RE: PCN # ESW490-25 -- TO-220 non-isolated and TO-263(D2PAK) lead frame design change

## Product/Process Change Notice (PCN)

**PCN#:** ESW490-25    **Date:** Oct 30, 2015

# PCN Report

Thyristor TO-220 non-isolated and TO-263 (D2Pak) Product Series

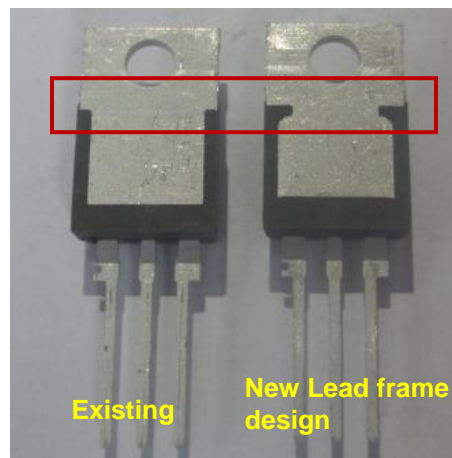
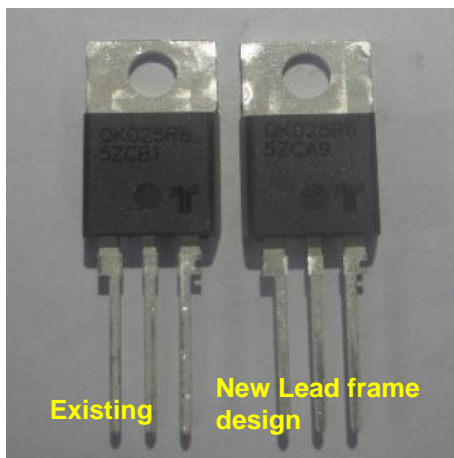
## 4.0 Physical Differences/Changes:

- 1) There will be no change in physical dimension and marking.
- 2) No change on topside of finished goods, minor (non-impact) change in backside appearance of finished goods.
